From: Amanda Scholes on behalf of Planning.Responses
Sent: 26 July 2017 10:28
To: Planning Scanning
Subject: FW: Fitzalan Link - LU.234.16.RES

In summary, there appear to be just three outstanding points now – the choice of road surface, the requirement for a new or supplementary Stage 1 Road Safety Audit and the design of the shared footpath-cycleway connection to Highdown Drive close to the new

Cycleway Connection to Highdown Drive.

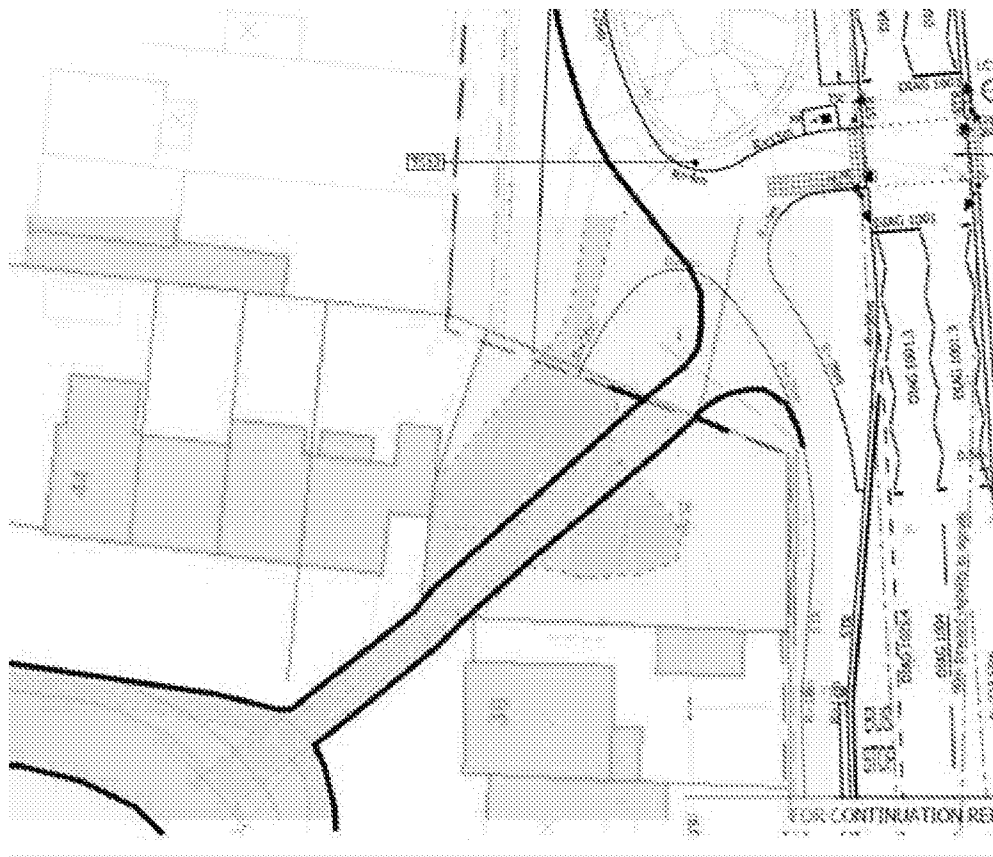
You have again offered an explanation for the path alignment in the vicinity of the Toucan crossing and balancing pond. The radii proposed are acceptable to us but the path must connect properly to the path leading to Highdown Drive which should be upgraded to a shared footway-cycleway. I have indicated below what this might look like. However, looking at this again shows the pink area to be public highway and on the line of part of Public Footpath 3103. Therefore, it is recommended (and indeed appears more straightforward) to retain this line otherwise it appears that any continuation of the route south of your scheme might cross land that might not be highway. Any path should be lit, edged, resurfaced, signed and tactile-paved appropriately although these final details can be shown at the S38/278 stage. Any upgrade from Public Footpath to shared footpath-cycleway must be undertaken in-accordance with WSCC PRow procedures.

The highway boundary plan and alignment of the existing PRow is noted. However, this is not evident on the ground since the Academy has been constructed (see extract from Google Earth below). We can show the alignment requested, (based on the OS Highway Boundary plans provided) but we would only have the power to construct the pathway up to our limit of ownership (the red line). WSCC has less than Freehold rights beyond the red dashed line and as such we don't believe we would have any power to undertake works on this area of land (see attached) to effect the PRow route beyond the red line, hence the reason for showing the tie-in (at the limit of ownership) to the existing physical route present on the ground. Therefore, we believe that what we have shown on the submitted drawings is the best solution, unless WSCC can confirm that we could legally obtain power to undertake works on land that they don't have complete freehold rights over.
